MFN 07-007

Docket No. 52-010

Subject: Response to Portion of NRC Request for Additional Information Letter  
No. 59 Related to ESBWR Design Certification Application ESBWR  
Probabilistic Risk Assessment RAI Number 19.1-37

**Response to Portion of NRC Request for  
Additional Information Letter No. 59  
Related to ESBWR Design Certification Application  
ESBWR Probabilistic Risk Assessment  
RAI Number 19.1-37**

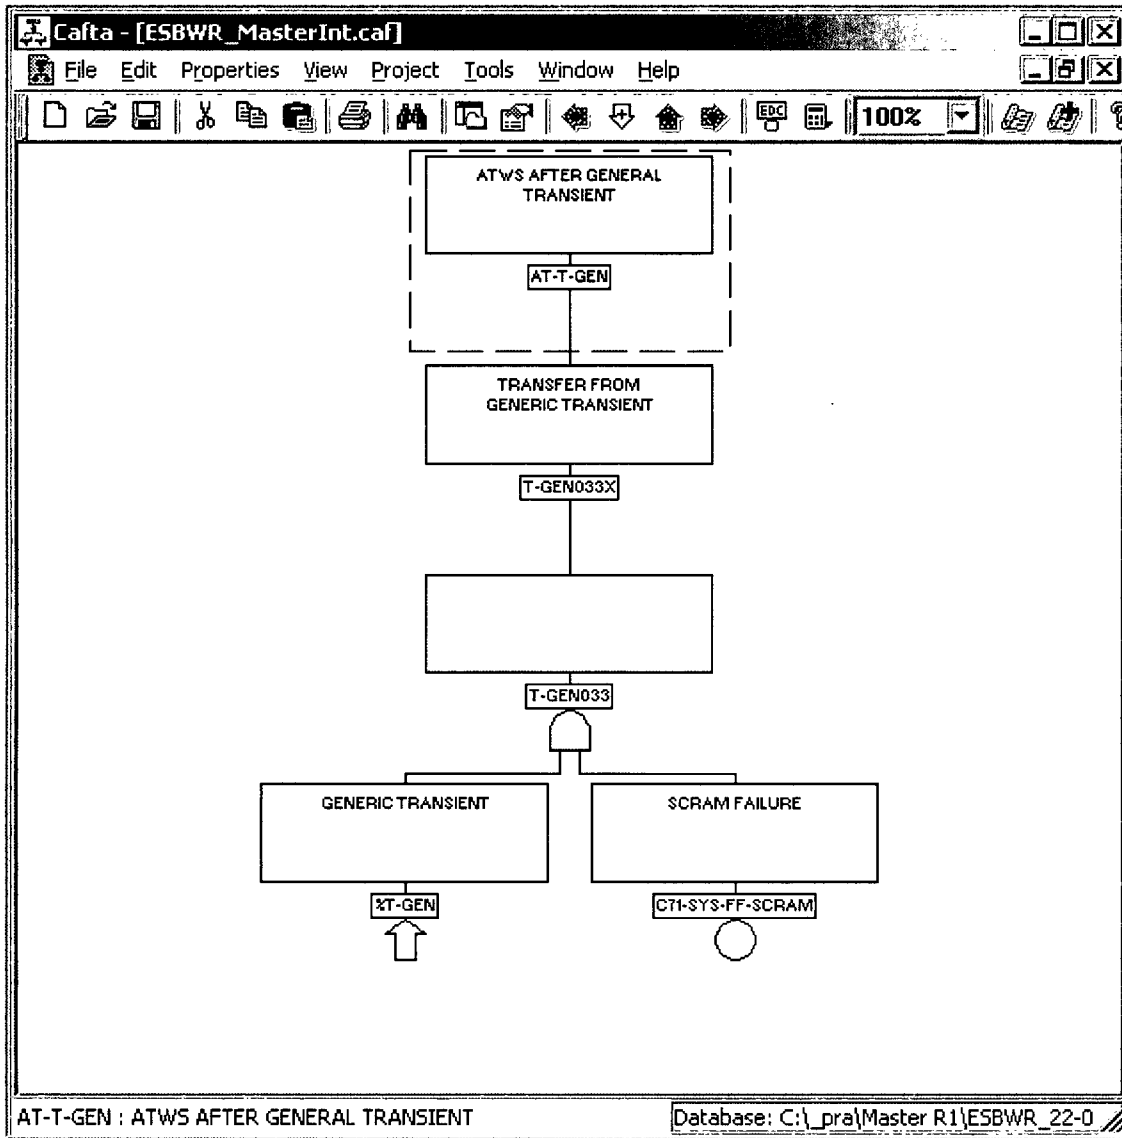
*The reactor scram function (event tree heading C) is discussed briefly in NEDO-33201, Section 3. It is stated (page 3.3-10) that "The initiating event for the ATWS [anticipated transient without scram] event tree is a fault tree with the general transient ANDed with the failure of the RPS [reactor protection system] and/or ARI [alternate rod injection]...." However, additional information on the modeling of this function is needed. Please address the following:*

- A) *Provide the fault tree mentioned in the above statement (top event C71-SYS-FF-SCRAM) with adequate explanation to understand how the failure of the reactor scram function was modeled in the PRA.*
- B) *Explain how the assumed probability of  $5.8E-7$  (reported in Chapter 11, Table 11-2) for failure to scram was calculated*

- A) The logic used in the PRA model for ATWS scenarios has been developed as a point estimate combined with a transient event. The attached fault tree illustrations show examples of the logic used for ATWS after a general transient, and also for ATWS after a small LOCA.
- B) NEDO 33201 has been updated to Revision 1. The updated probability of failure for event C71-SYS-FF-SCRAM is  $1.0E-8$  in Table 5.4-1. This value was derived for the ABWR using a fault tree model of the Control Rods, including the FMCRD. Because the system is the same as the ESBWR design and it is independent of other systems in the ESBWR, the point estimate from the ABWR analysis applies to the ESBWR. The next revision of the PSA intends to include ESBWR specific fault trees of the SCRAM function.

Fault trees representing the above three situations are presented in Figures 19D.6-17, through 19D.6-19. Failure rate data are furnished in Table 19D.6-9.
